**Broward County's Complete
Response to the March 13, 2009
FDEP Review Letter on the
Port Everglades Feasibility and
Technical Study for the Creation
of Mangrove Wetlands**

Broward County

September 18, 2009

Project #172284

PORT EVERGLADES CONSERVATION EASEMENT
PORT EVERGLADES
BROWARD COUNTY, FL
SITE A CROSS SECTIONS

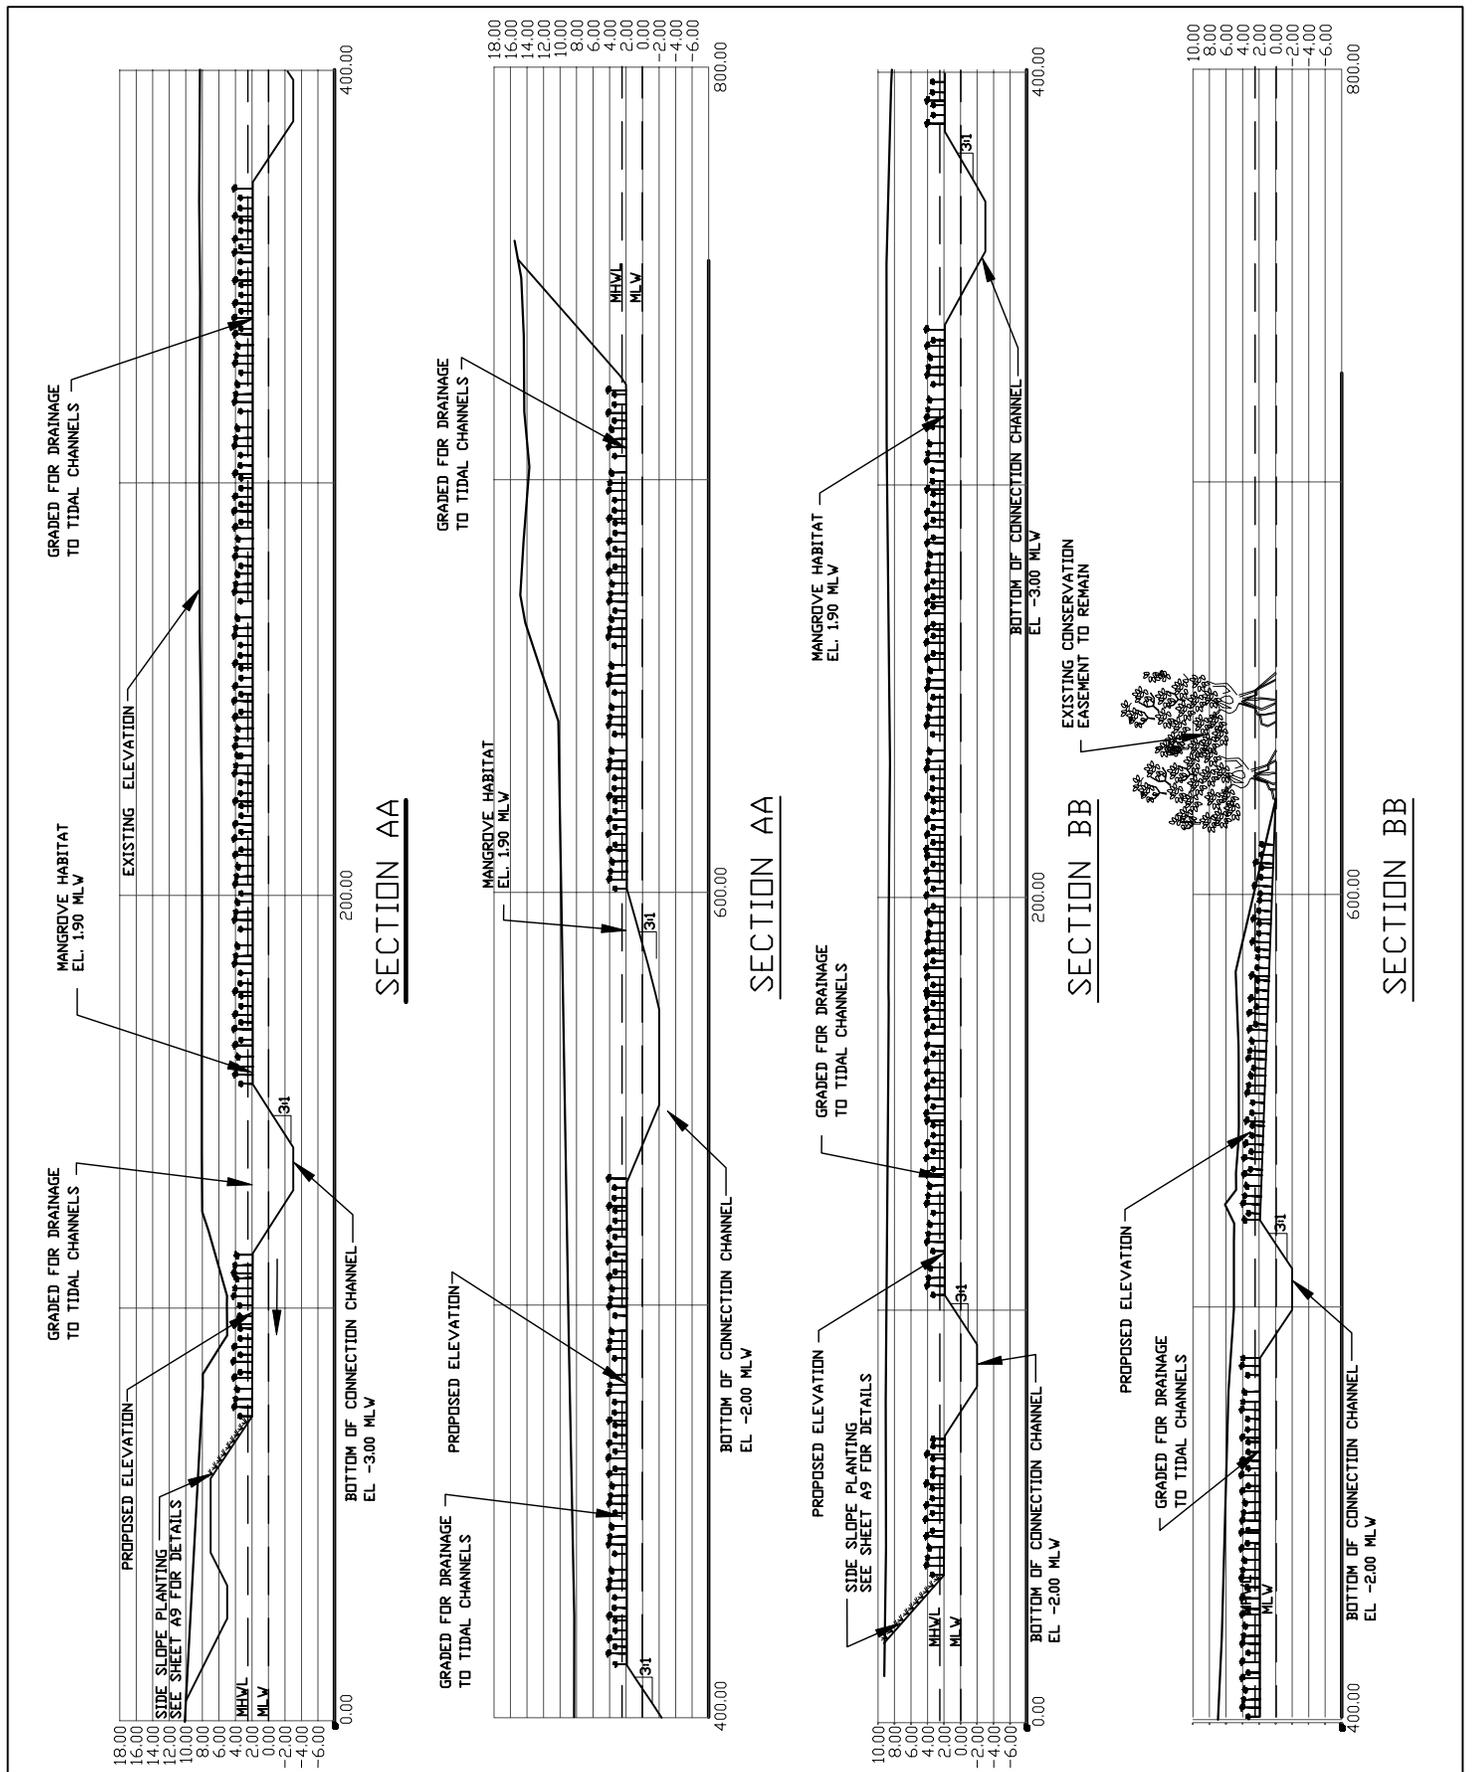
- c. *The plan view of Site A shows (on Sheets A2 and A3) the transect lines for Cross-Sections A and B, both of which cross three (3) flushing channels on the plan view. However, Cross-Sections A and B are shown (on Sheet A6) to cross five (5) flushing channels each.*

Broward County May 28, 2009 Response: The corrected cross section drawings are attached (see Appendix RAI-1-B, Sheets A2, A3 and A6).

Broward County Supplemental Response: As noted in our comments on FDEP Item 3, the size of the wetlands creation area has been modified from that previously provided. Please see Appendix RAI-1-D-Revised Project Drawings-September 18, 2009 and Appendix RAI-1-F-Revised Concept Plan-September 18, 2009 for the most current drawings.

Figure 2.1
 Existing Drainage Map
 Conservation Easement Assessment
 Port Everglades
 Broward County, Florida

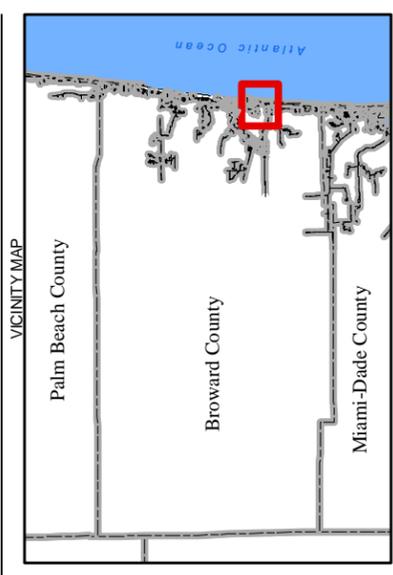
FDEP COMMENT: The stormwater drainage study appears limited to the area north of Access Road. However, the study does not consider the paved container area labeled "Berth 34" in Figure 2.1 (see Section 4 of the report). This area borders approximately 1500 linear feet of the conservation easement, so understanding how the container yard is connected to (or isolated from) the proposed CE is critical to potential impact and overall water quality estimates. What drainage analysis is available for this area? What treatment is in place, and are any treatment improvements proposed?

Broward County Supplemental Response: As requested by FDEP, the drainage study area was expanded to include the paved container area bordering the conservation easement. That area is commonly referred to as SOUTHPORT Phase VA & VB. The Drainage Supplement (Appendix RAI-1-C) includes drainage information pertaining to the SOUTHPORT Phase VA & VB, including the location of existing water quality treatment facilities affected by the proposed wetland creation area. Storm water from the Southport area is collected and conveyed to an exfiltration system and stormwater treatment swale. The retention volume provides 50% of the required water quality treatment volume in accordance with SFWMD regulatory requirements. Stormwater runoff volumes in excess of the retention volume discharge to the conservation easement and existing injection well. These drainage improvements were designed, constructed, and permitted under SFWMD permit number 06-00927-S dated February 14, 1991. The flow of stormwater runoff from the SOUTHPORT Phase VA & VB to the CE is proposed to remain as is and is not expected to adversely impact the CE.

FIGURE 3.2
Drainage Concept Plan
 Conservation Easement Assessment
 Port Everglades
 Broward County, Florida

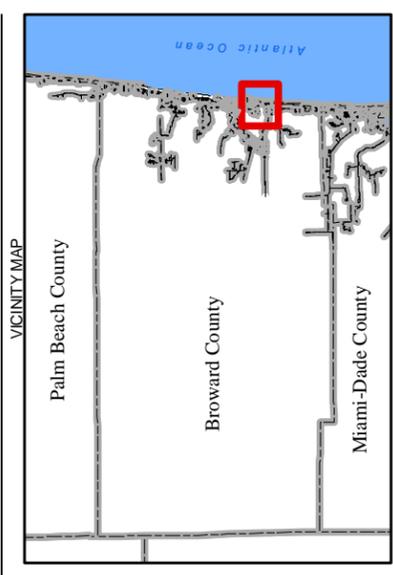
- Measures should be proposed to remove oil and grease from stormwater runoff to the E-W ditch.

Broward County Supplemental Response: An oil-grit separator (a.k.a. oil-water separator) is proposed to remove trash, debris, sediment, oil and grease from stormwater runoff discharging from upland drainage areas to the E-W Ditch. The location and details of the oil-grit separator are included in the Drainage Supplement Report (Appendix RAI-1-C).
